OWNER / DEVELOPER:
TARAHUMARA TRUCKING, LLC
14221 E 4TH AVE, SUITE 221
AURORA, CO 80011
JULIO HERRERA
720-638-1114
TARAHUMARATRUCKINGLLC@GMAIL.COM

TARAHUMARA SUBDIVISION FILING NO. 1

COVER SHEET
2260 ANDES WAY

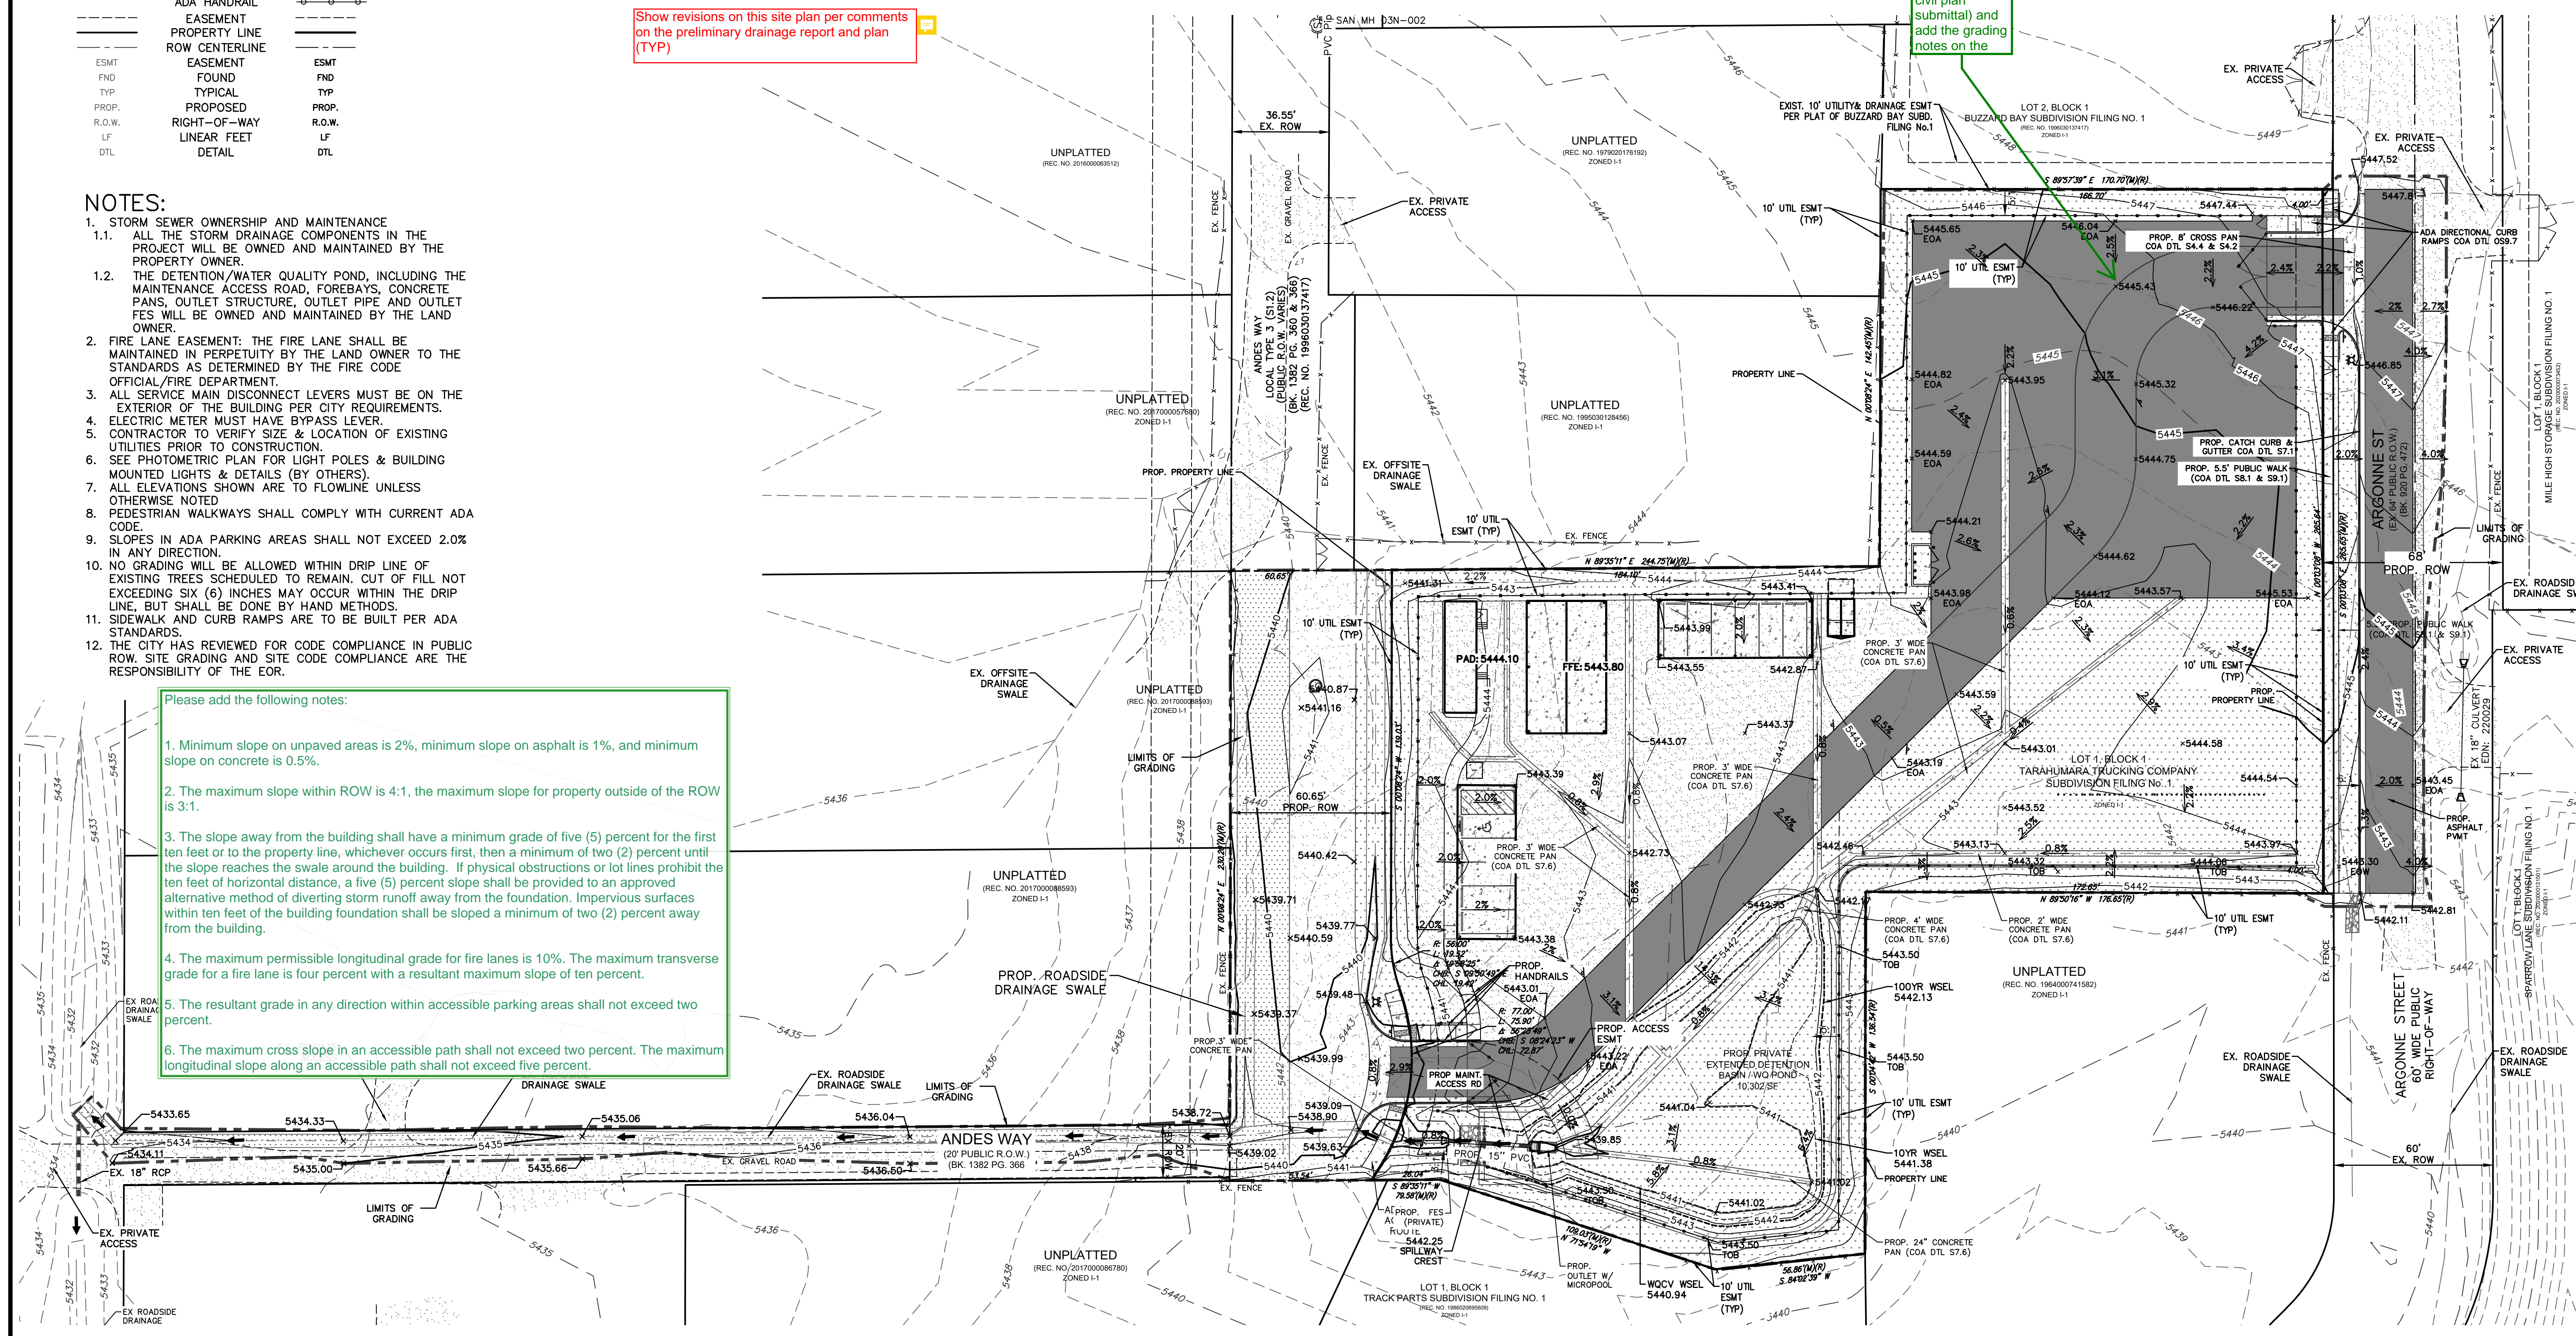
- Please add the following notes:
- Minimum slope on unpaved areas is 2%, minimum slope on asphalt is 1%, and minimum slope on concrete is 0.5%.
 - The maximum slope within ROW is 4:1, the maximum slope for property outside of the ROW is 3:1.

- The slope away from the building shall have a minimum grade of five (5) percent for the first ten feet or to the property line, whichever occurs first, then a minimum of two (2) percent until the slope reaches the swale around the building. If physical obstructions or lot lines prohibit the ten feet of horizontal distance, a five (5) percent slope shall be provided to an approved alternative method of diverting storm runoff away from the foundation. Impervious surfaces within ten feet of the building foundation shall be sloped a minimum of two (2) percent away from the building.

- The maximum permissible longitudinal grade for fire lanes is 10%. The maximum transverse grade for a fire lane is four percent with a resultant maximum slope of ten percent.

- The resultant grade in any direction within accessible parking areas shall not exceed two percent.
 - The maximum cross slope in an accessible path shall not exceed two percent. The maximum longitudinal slope along an accessible path shall not exceed five percent.

(2) 11.5' MANUAL SWING GATES WITH KNOX HARDWARE DETAIL (WEST)
N.T.S.

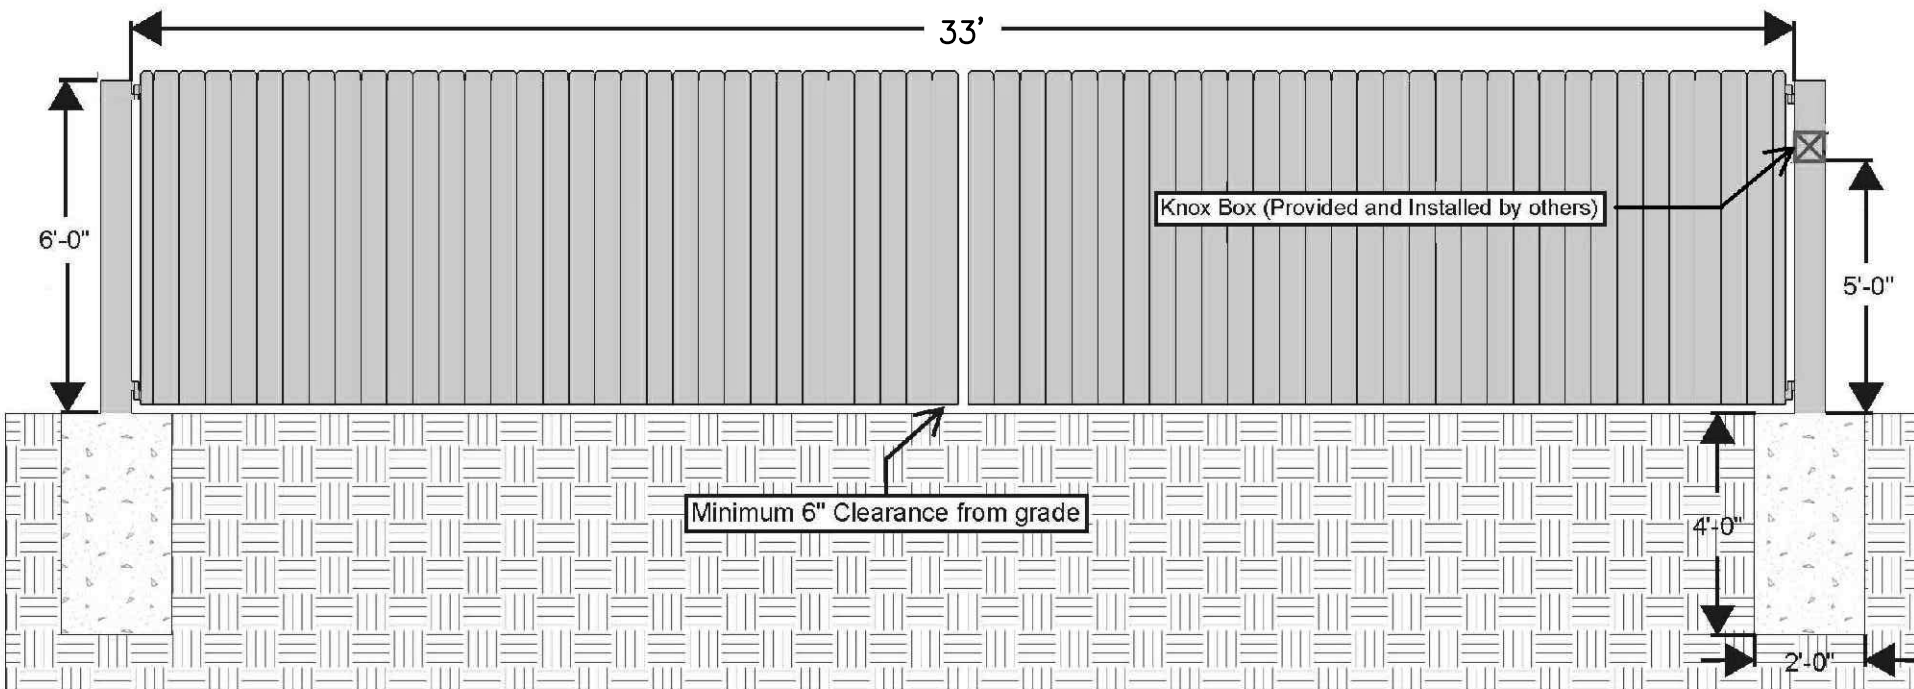
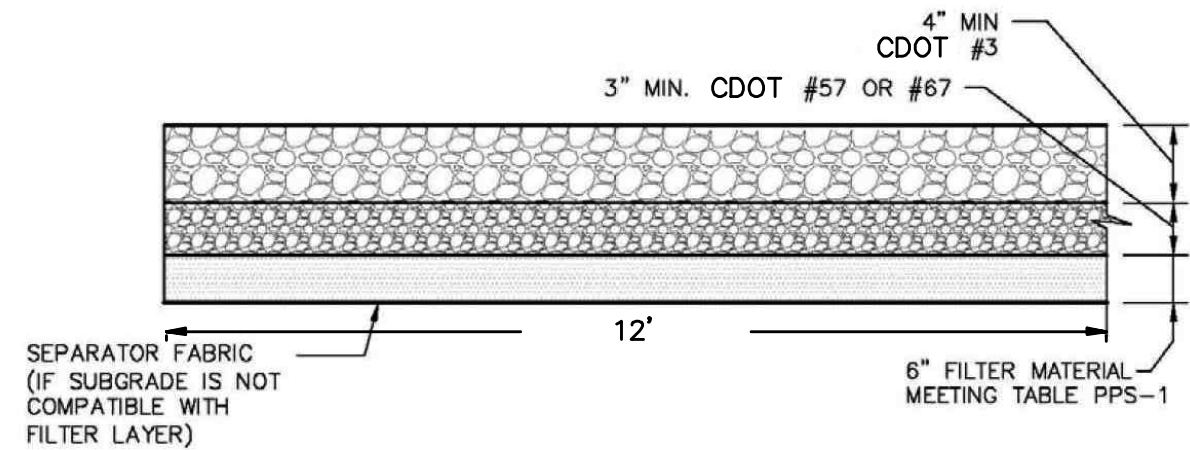
Provide details for the man gates on the east and west side.

Provide basic details for the proposed shade structure.

Provide basic details for the proposed electrical enclosure.
